Serial No. NA3-10-003
Docket No. 52-017
COL/BCB

DOMINION VIRGINIA POWER
NORTH ANNA UNIT 3 COMBINED LICENSE APPLICATION
QUALITY ASSURANCE PROGRAM DESCRIPTION REVISION

**Summary and Evaluation of Changes to
North Anna Unit 3 Quality Assurance Program Description,
Topical Report DOM-QA-2**

**Marked-up Copy of
North Anna Unit 3 Quality Assurance Program Description,
Topical Report DOM-QA-2**

Figure II-1 Pre-construction Organization

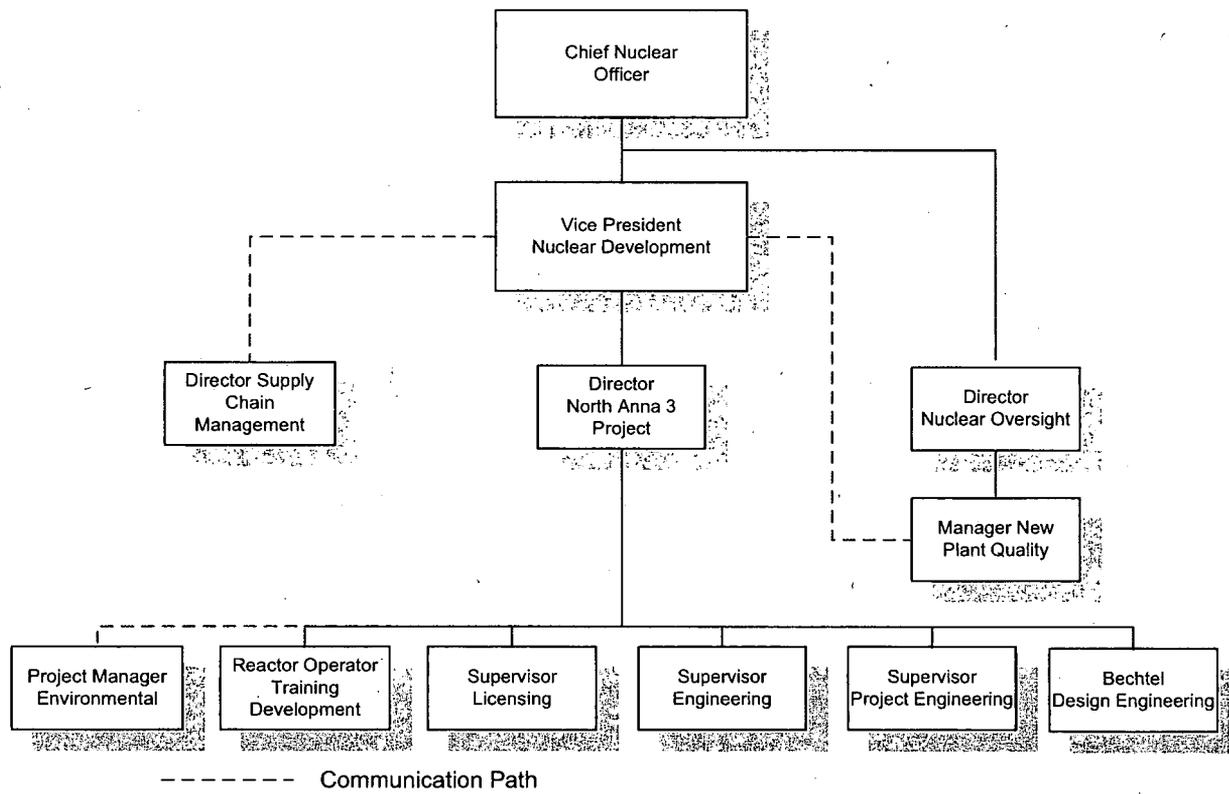
Section 1.2.1.1 – Clarified the duties and responsibilities of the engineering design services performed for the site as part of work necessary to establish a standard plant design on the North Anna site. Organization Chart II-1 was updated to reflect the use of Bechtel as a supplier to the Nuclear Development group. This function remains part of the overall QA organization as a delegated duty and continues to meet the requirements of 10 CFR 50, Appendix B, Criterion I. The reference to the duties of GEH relative to long-lead items was removed since Dominion has discontinued that purchase agreement. The sentence regarding Dominion reviewing and auditing suppliers on a regular basis to ensure conformance with the quality requirements was deleted since it is redundant to the QA requirements specified in Part II, Section 7.1 of the QAPD. These changes update the QAPD to the current scope of work for North Anna 3.

Figure II-1 was updated to show the Bechtel interface with the organization.

Figure II-3 Operating Organization

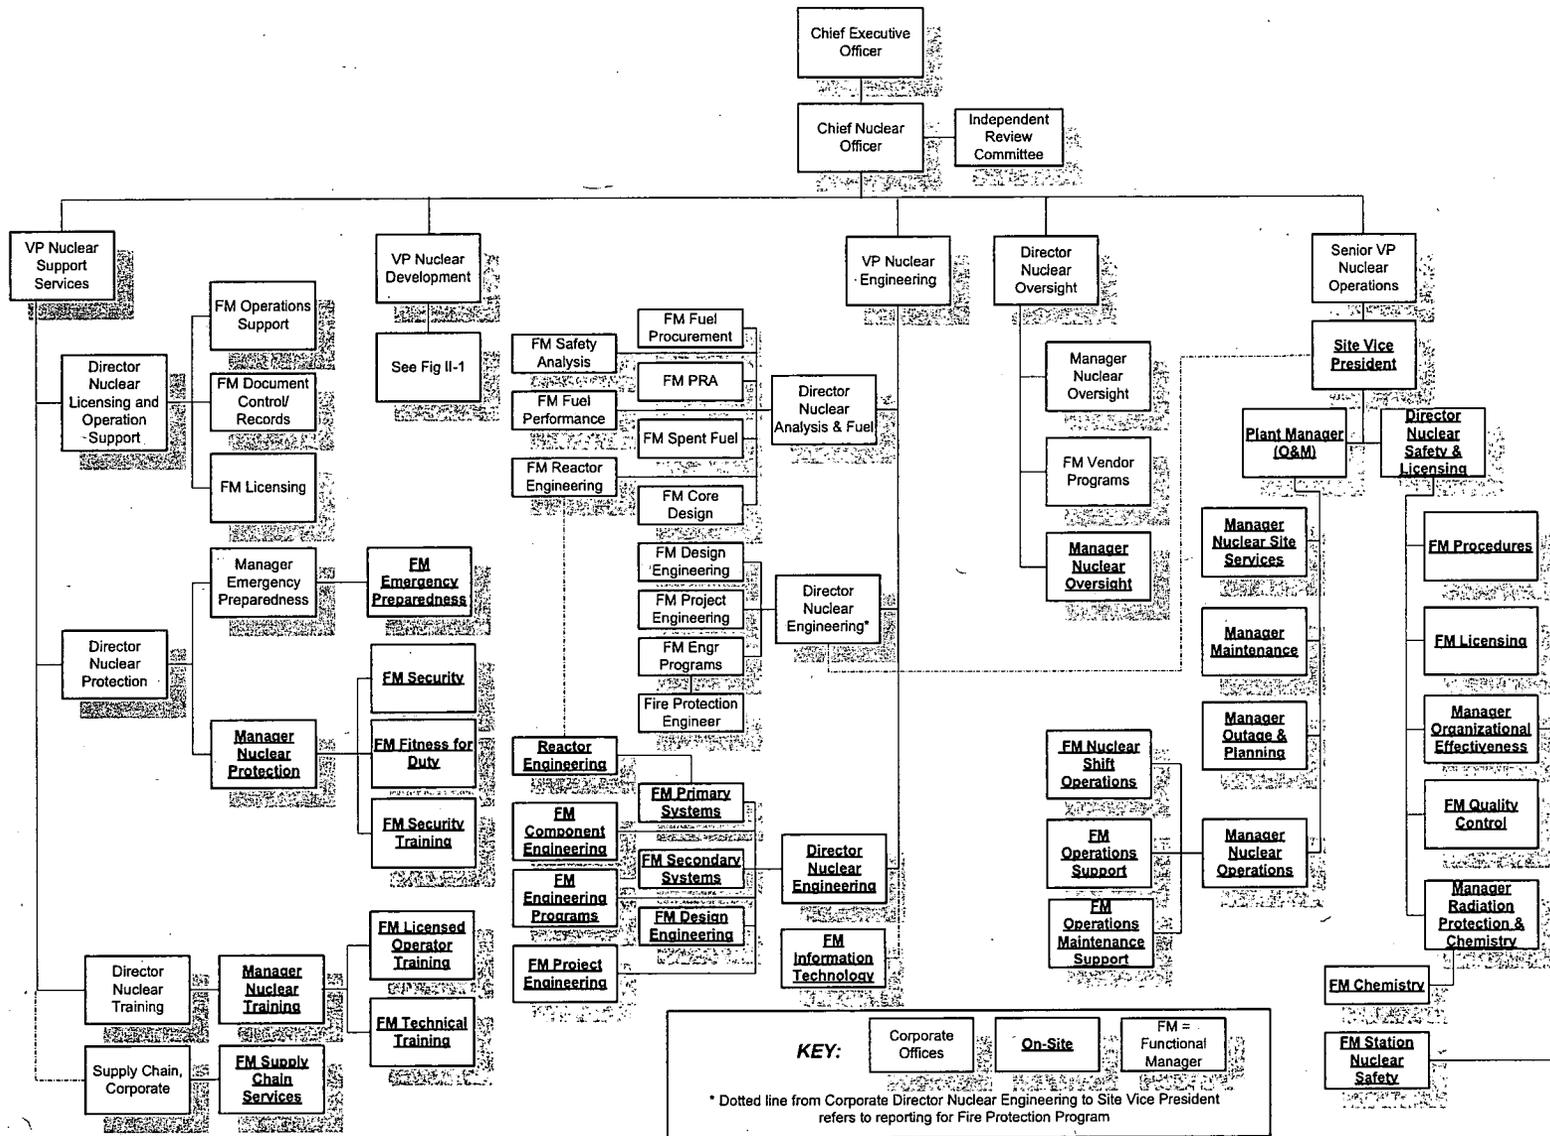
(IRC) as delineated in NEI 06-14-A, Rev. 1 (ref. NUREG-0800, SRP 17.5). The North Anna 3 QAPD is changed to use the IRC approach. The IRC reports to the CNO as depicted in the updated organization chart, Figure II-3.

Section 1.7.1.1 – Added the Document Control and Records function that was relocated from Section 1.6.1.3.1. Organization chart, Figure II-3, was updated to reflect this relocation. This change matches the revised operating organization structure currently in place for the Dominion operating plants. The QA function remains as part of the overall QA organization; therefore, 10 CFR 50, Appendix B requirements continue to be met.

Figure II-3 was updated to show the reporting of the IRC to the CNO and the realignment of the Document Control and Records Management function in the Support organization.
